State of Alaska
Department of Fish and Game
Sportfish Division

Nomination Form
Anadromous Waters Catalog

Anadromous Waters Catalog Number of Water Body 111-50-10668

Nomination # 24-515

Figure 1.-111-50-10668 route correction map.

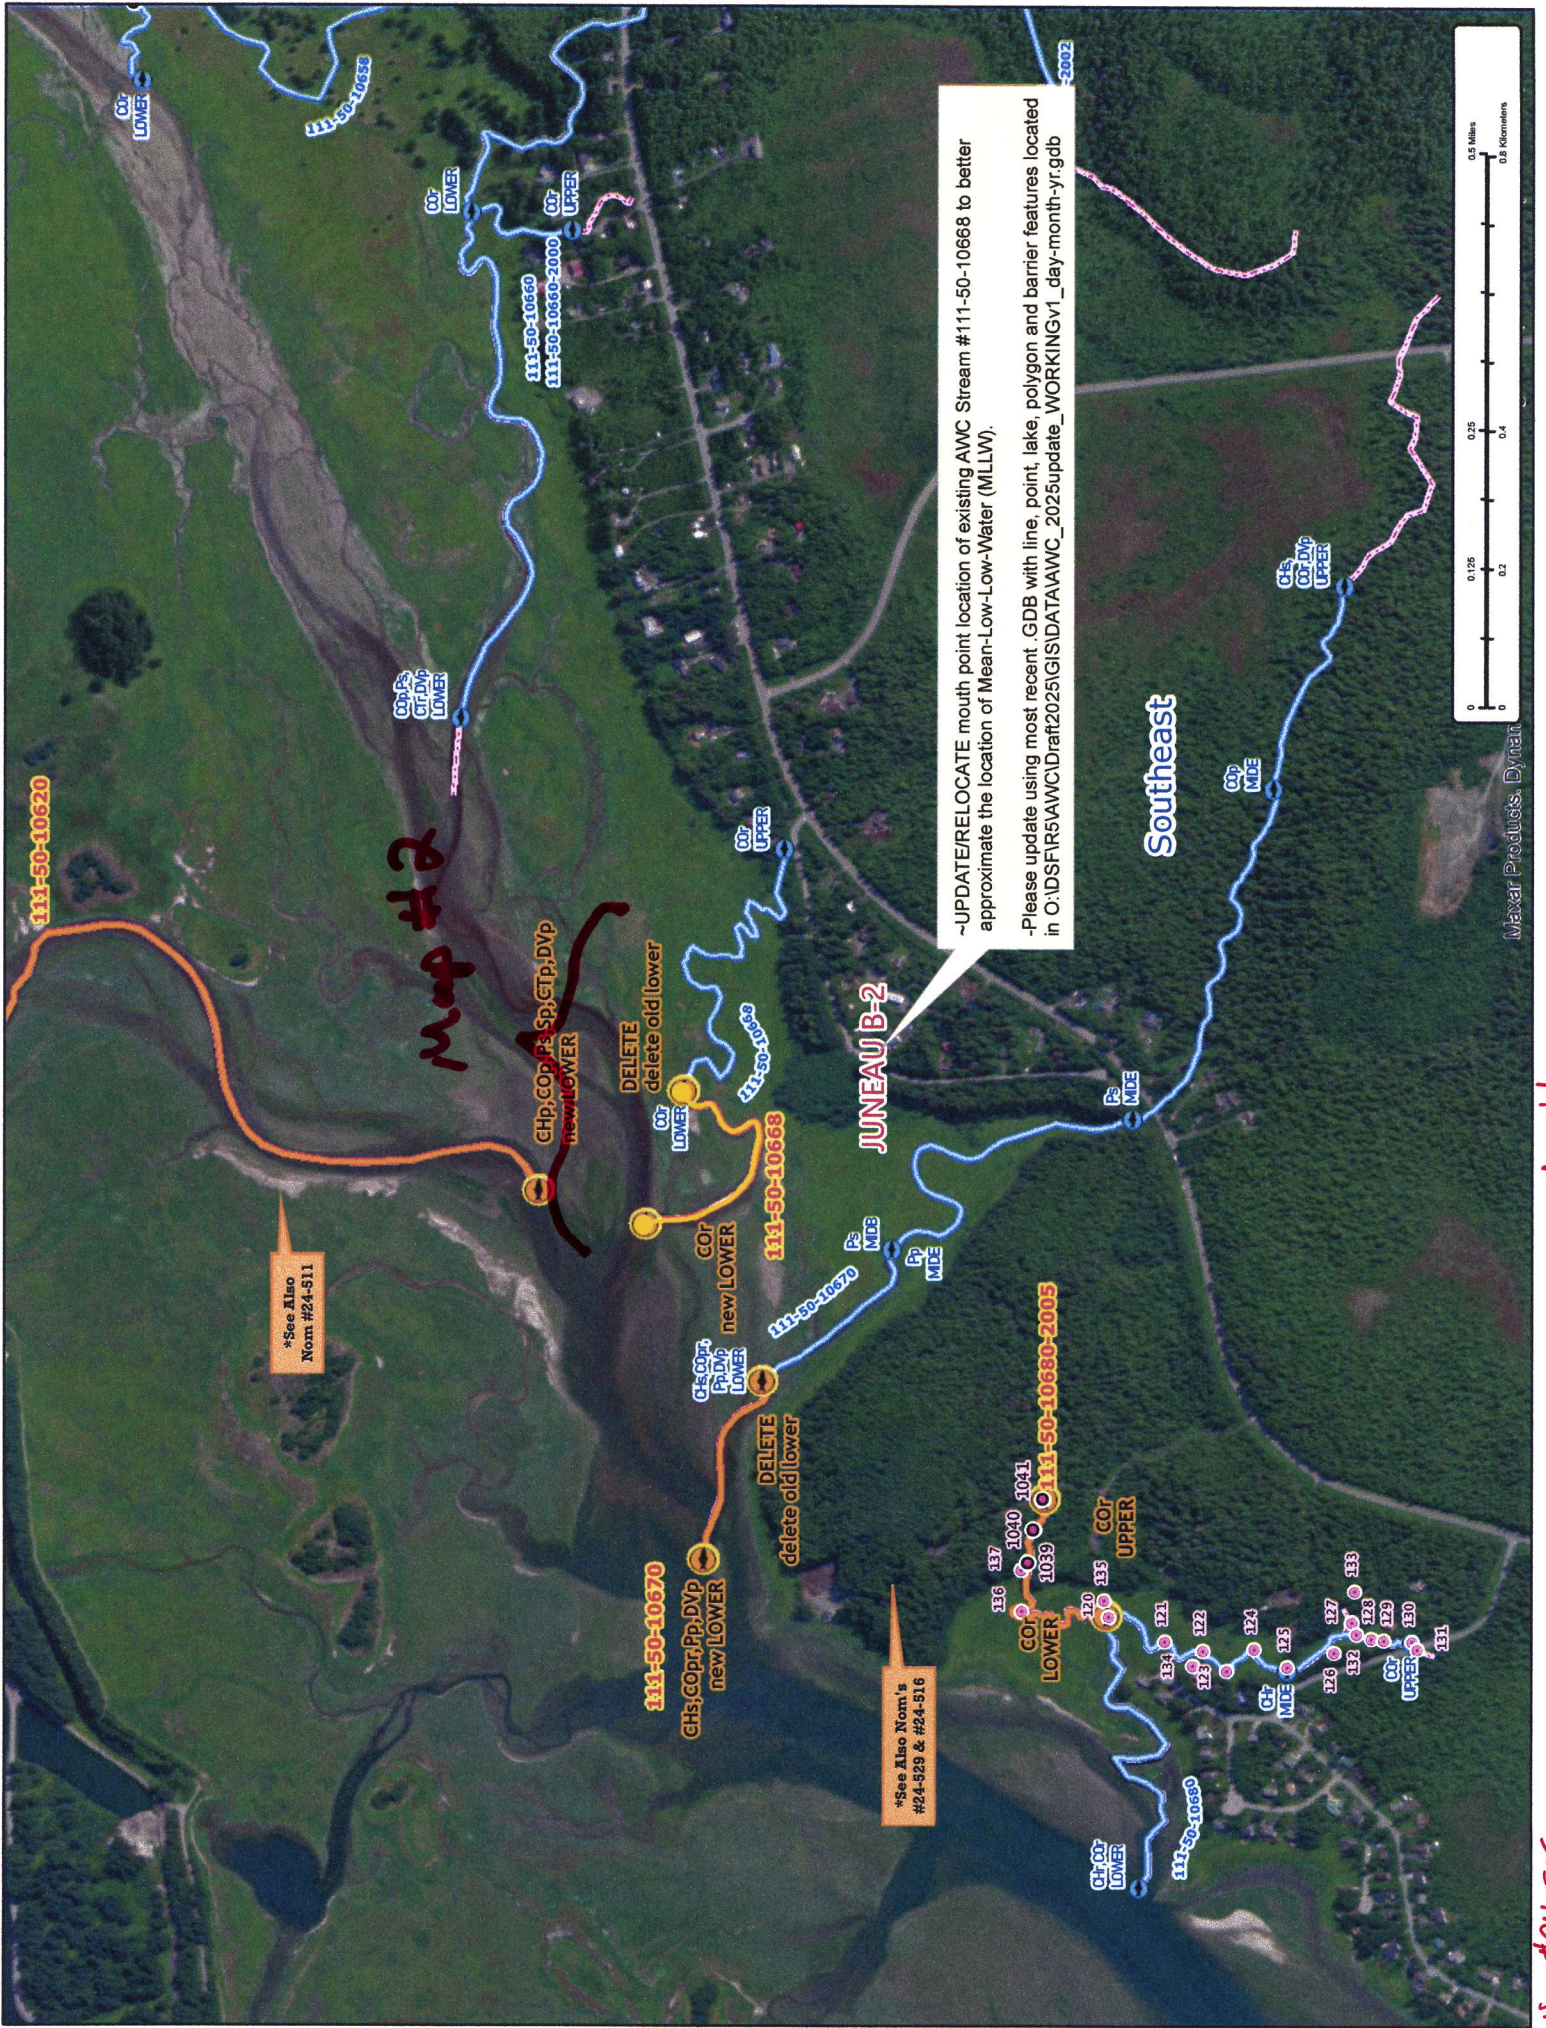
Findings: We surveyed this cataloged stream and found that the stream path is incorrectly mapped. The lower reach of the stream should be extended for clarification, particularly in light of potential alternatives identified for eventual construction of a second bridge crossing between Juneau and Douglas.

Recommendations: Correct Stream No. 111-50-10668 in the anadromous waters catalog to reflect the field verified stream path. Please extend stream into the intertidal (Figure 1).

~UPDATE/RELOCATE mouth point location of existing AWC Stream #111-50-10688 to better approximate the location of Mean-Low-Low-Water (MLLW).
-Please update using most recent .GDB with line, point, lake, polygon and barrier features located in O:\DS\FR5\AWC\Draft2025\GIS\DATA\AWC_2025update_WORKING\1_day-month-yr.gdb
